APPLICATION NO.	FILING DATE	FIRST NAMED INVENTOR	ATTORNEY DOCKET NO.	CONFIRMATION NO.
10/050,536	01/18/2002	Yasuhiro Nonobe	218190US2	7743

Office Action Summary

10/050,536

FIG. 4

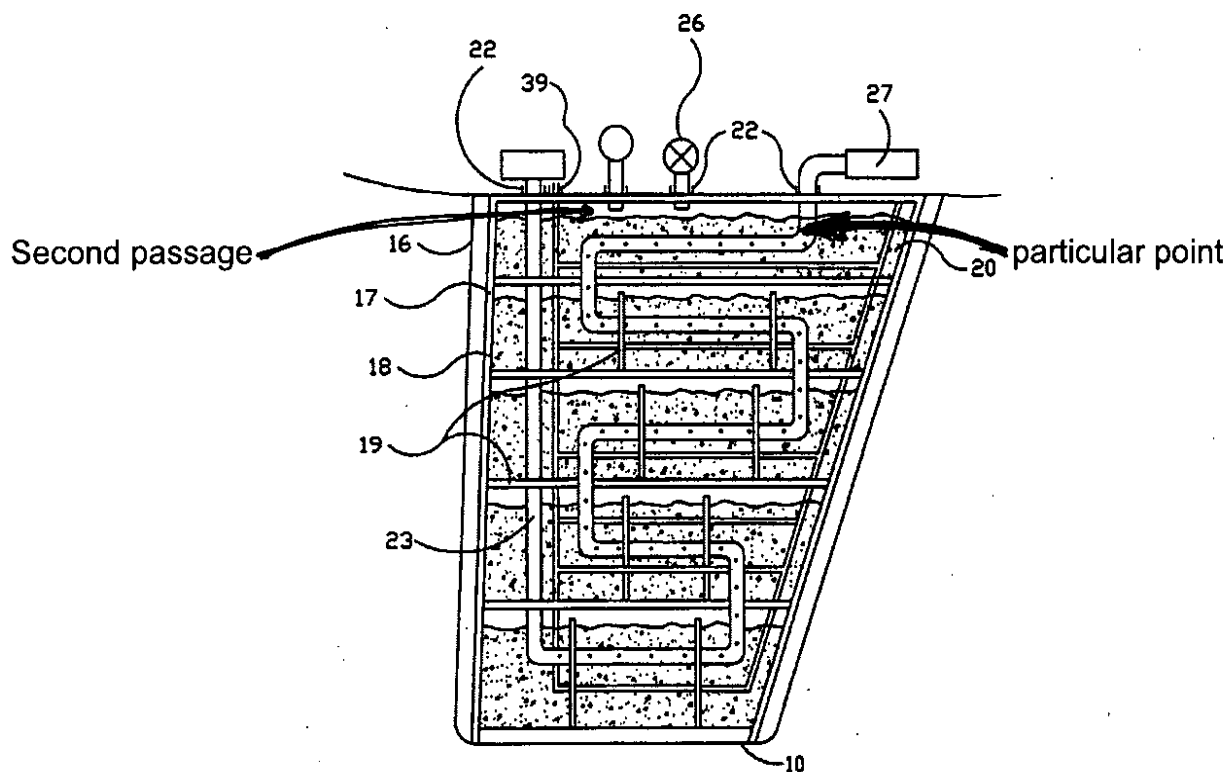
Rendina discloses an on-board fuel cell system to be installed on a ship. (See Fig. 1, ref. number 12, and column 4, lines 37-40.) As shown in Figure 4, the hydrogen storage system disclosed by Rendina includes a gas distribution line (23) which includes a first passage that connects the outlet of the gas storage device (22) with a

fuel cell (12). A heater (39) adjusts/reduces the pressure of hydrogen gas discharged from the hydrogen gas storage device since the amount of gaseous hydrogen in the keel is determined by the temperature of the ballast. A second passage is formed in the space at the top of the ballast container.

Pressure relief valve (26) as shown above, is located in the second passage. Thus, the claim is anticipated.

As discussed above, Rendina discloses applicants' invention essentially as claimed, with the exception that Rendina does not specifically mention orientations of the pressure relief valve shown with respect to road surfaces. However, one of ordinary skill in the art will recognize the ships described by Rendina will at least occasionally dock. In such a case, the pressure relief valve discharge will be directed towards the dock. A boat dock is considered to be a road, since it is an open way for vehicles, persons, and animals. Thus, one of ordinary skill in the art will recognize the hydrogen discharge described by Rendina will be directed towards a road surface.
